ADDENDUM

FINAL MITIGATED NEGATIVE DECLARATION FOR APOLLO SENIOR CARE FACILITY

**City File No. ENV19-0003
SCH# 2019119041**

June 7, 2021

Figure 2
APOLLO SENIOR CARE PROJECT
Rendering

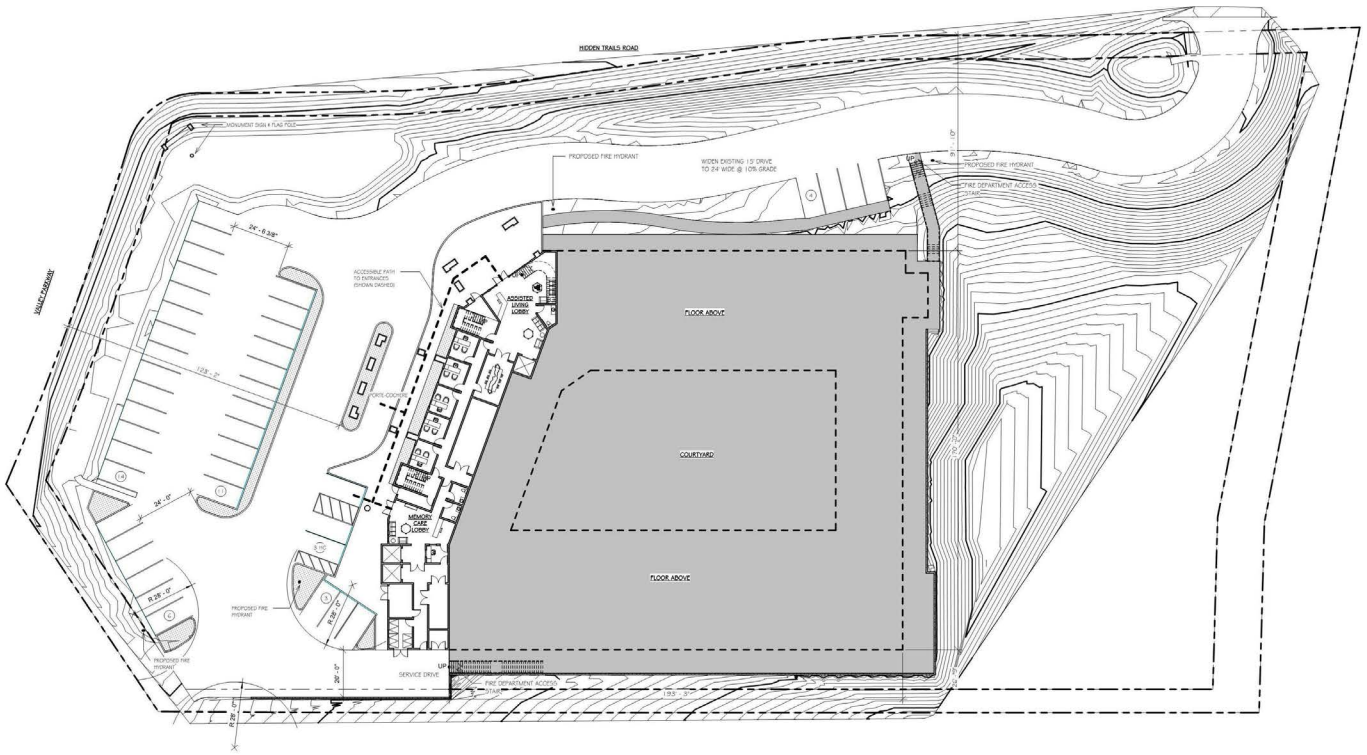
Since approval of the Final MND, the project site design was modified to increase the basement's interior floor area from 4,927 square feet to 8,026 square feet and the reconfiguration of interior use of the space to allow for laundry use. Design modifications also included detailing of the building façade. A comparison of the changes between the original site plan and the proposed improvements are shown on Figures 2 and 3. The modified plot plan would not change the number of units or result in an increase in traffic. Additionally, on January 21, 2020, following project approval, the project applicant (Apollo) received comments from the City of Escondido Fire Department requesting for the preparation of a fuel modification site plan. As a result, Brush Management Zone (BMZ) 1 and BMZ 2 overlays were added to the plot plan, as shown on Figure 4.

Figure 3
APOLLO SENIOR CARE PROJECT
Site Plans

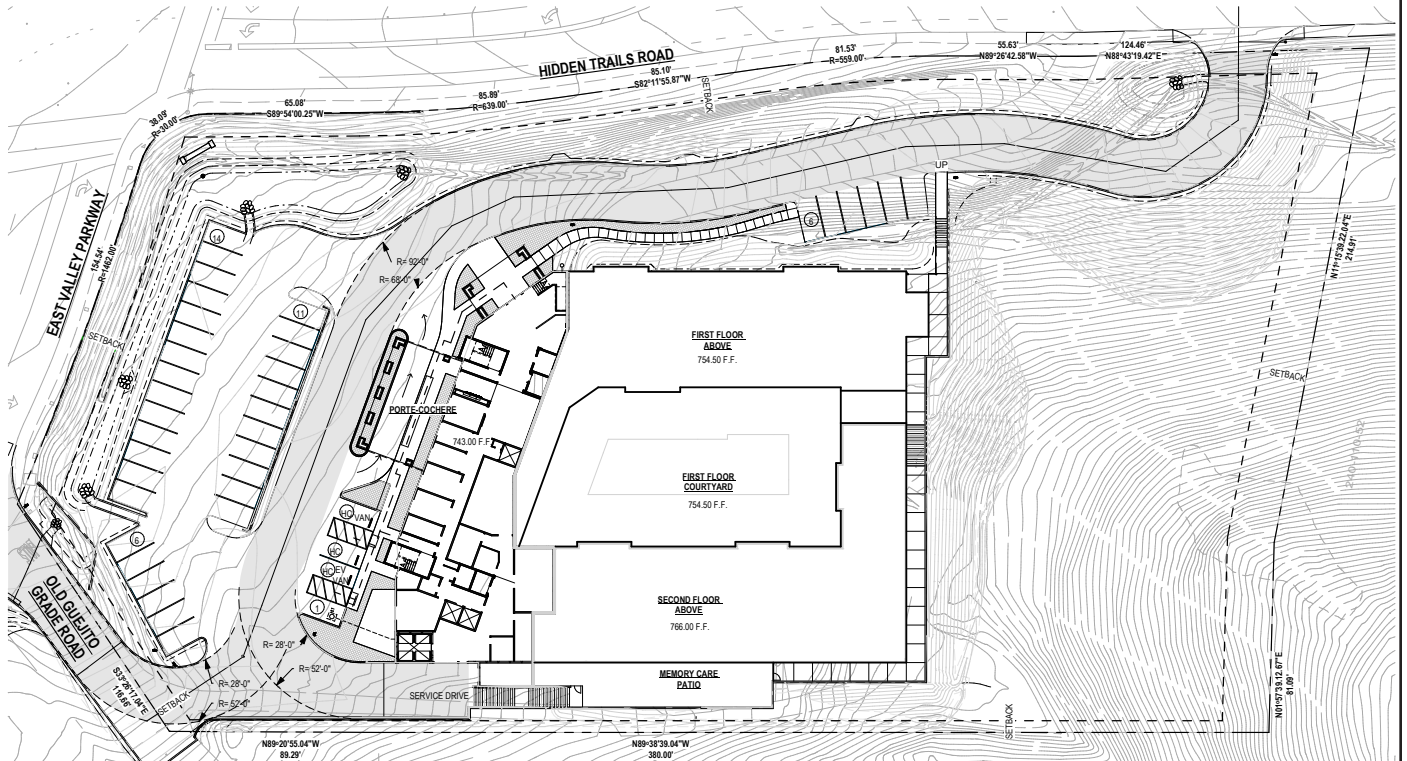
The originally approved project and proposed plot plan modification would affect the same project site; however, there was a slight change to the project impact area as a result of the addition of BMZ 1 and BMZ 2 to the plot plan, as shown in Figure 3. The BMZ indicates the area where fuel management would occur for fire protection purposes. BMZ 1 extends approximately 30 feet from

Figure 4
APOLLO SENIOR CARE PROJECT

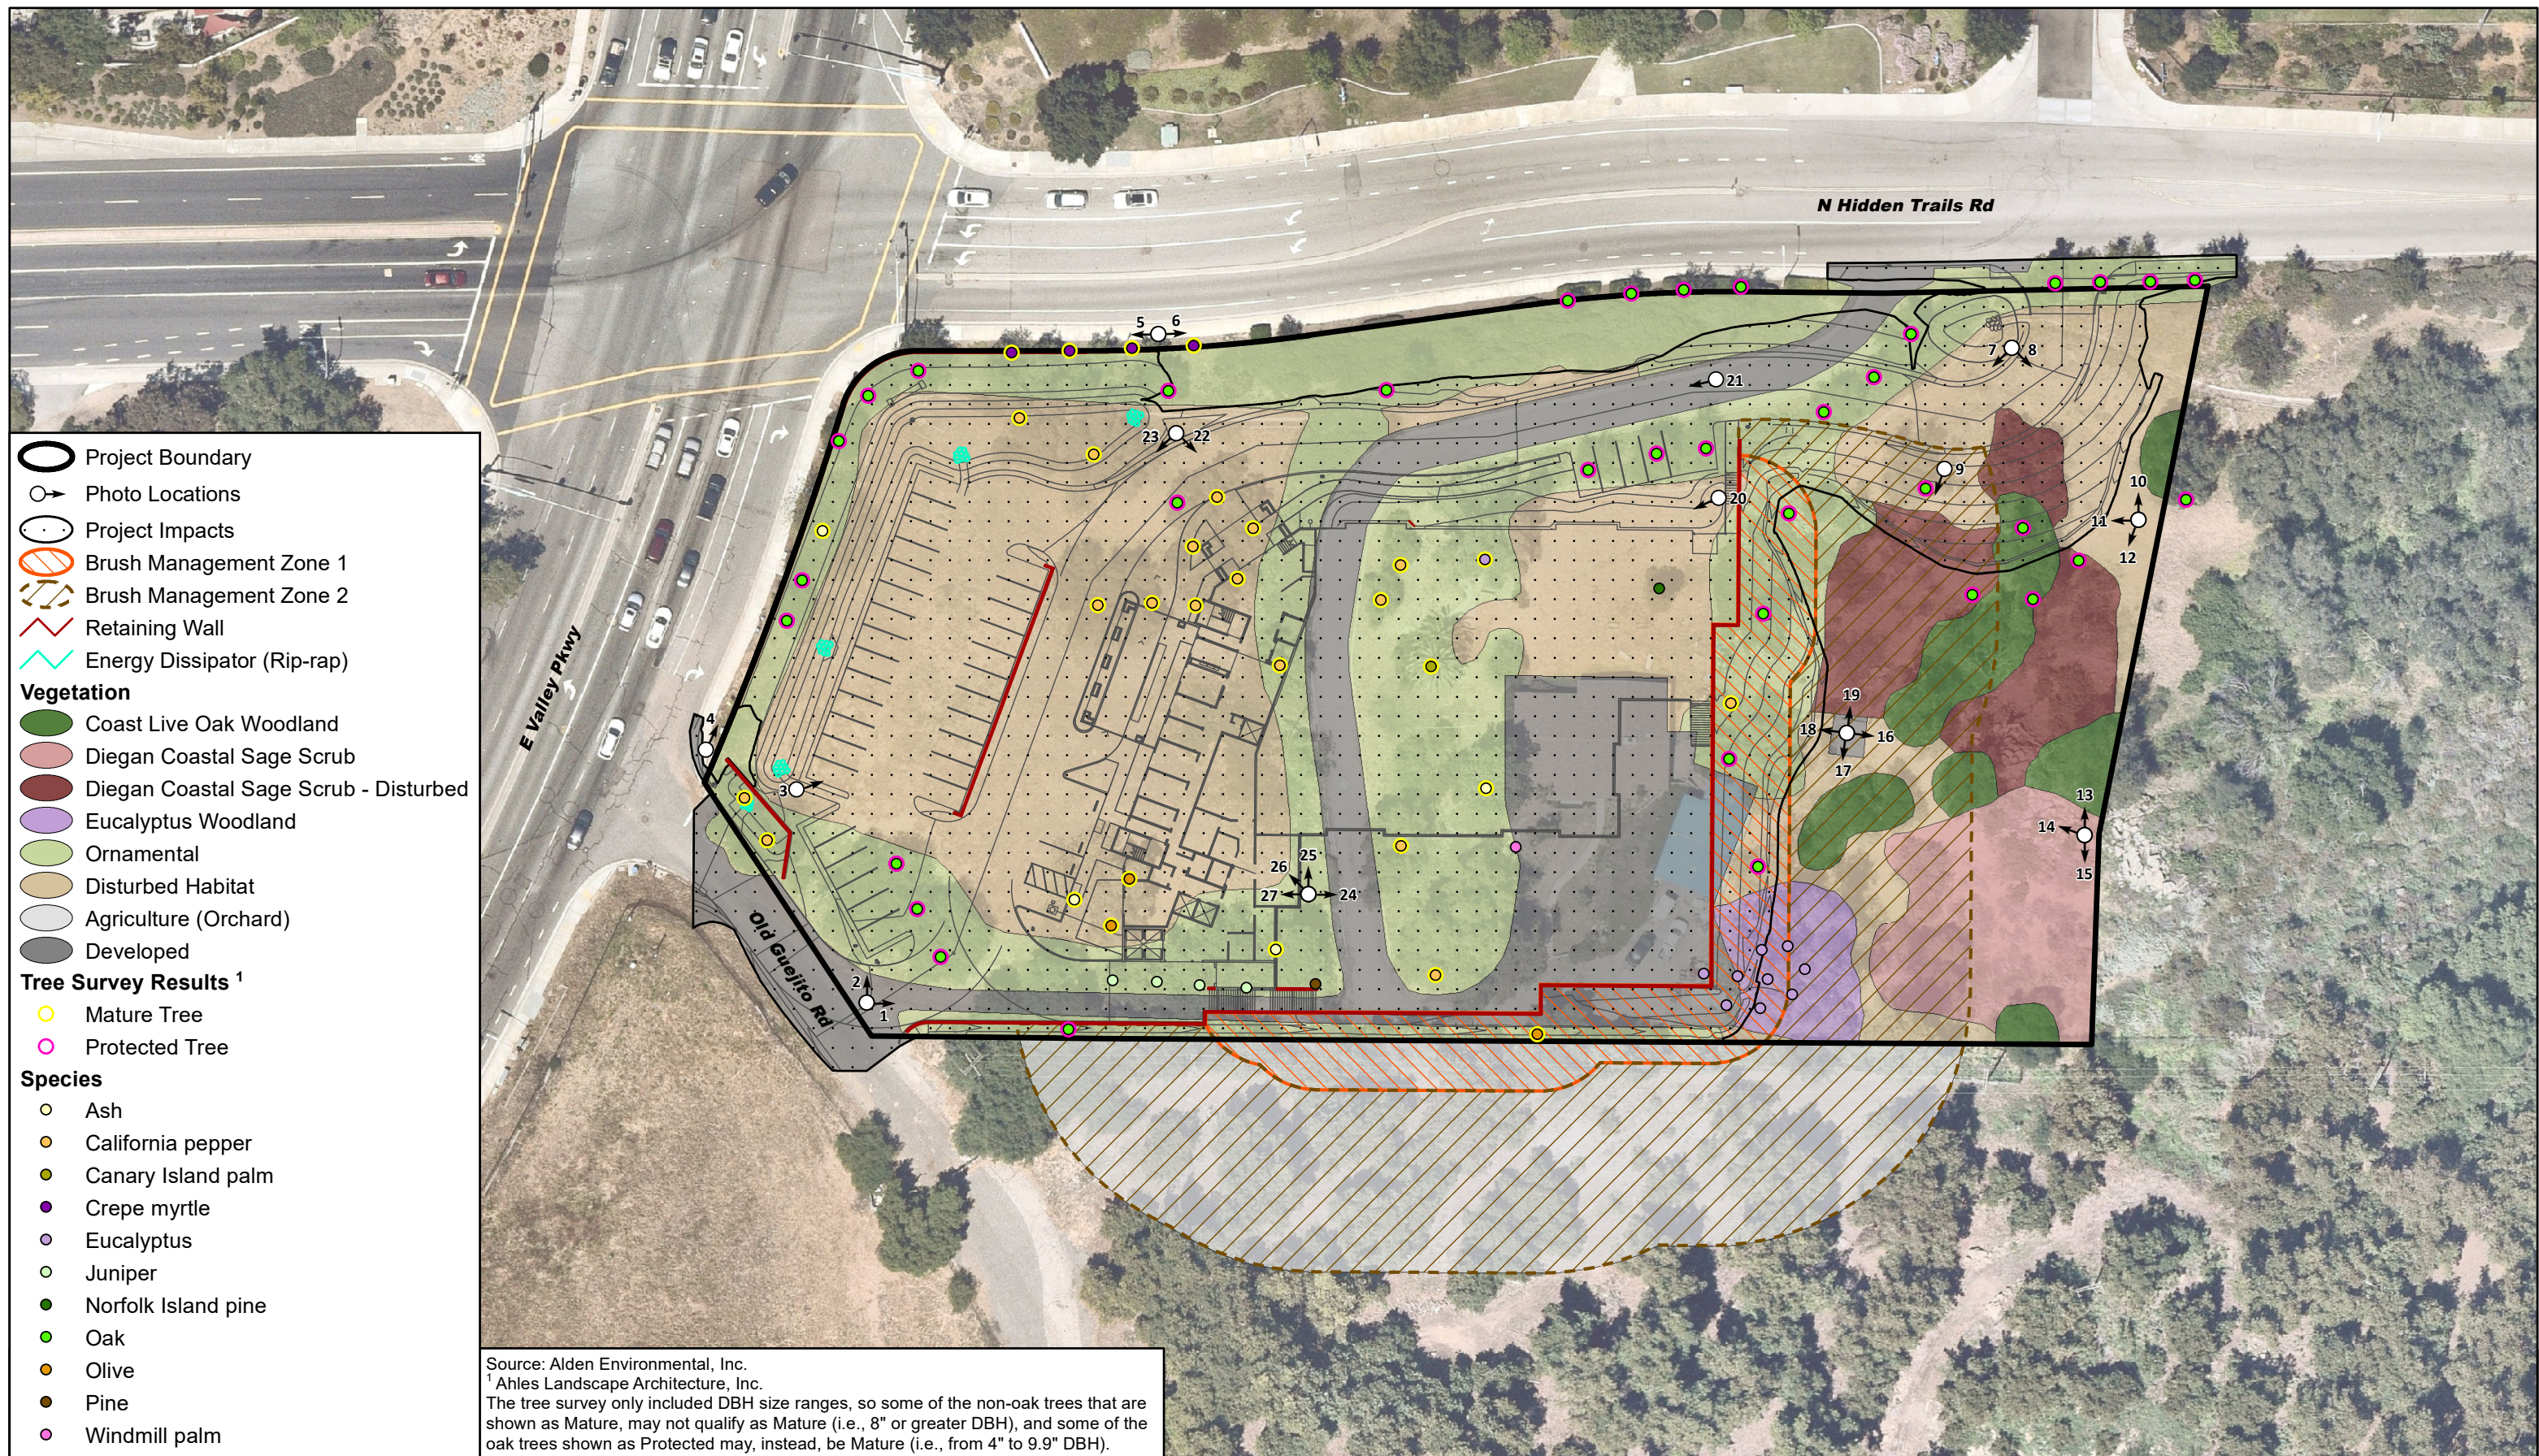
As shown in **Table 1** (impacts from original site plan) and **Table 2** (impacts with proposed modifications), fuel management activities associated with BMZ 1 and BMZ 2 would result in a slight increase of impacts on existing vegetation. The IS/MND identified a total impact of 2.49 acres on existing vegetation. With the addition of the BMZs, this area would increase to 2.65 acres, and the area would occur on non-sensitive areas previously addressed in the Biological Resources Report (Alden Environmental 2019). A GIS analysis was conducted to calculate impacts for BMZ 1 and found it was located either within the project grading area or within non-sensitive areas previously addressed in the Biological Resources Report. Impacts from BMZ 2 were determined to be non-significant as the level of management is lower and would not remove vegetation communities. An avocado orchard is located off site to the south of the project. A portion of the project's BMZ extends into this area, but there is no proposed off-site development. The avocado grove is not considered to be a sensitive biological resource.
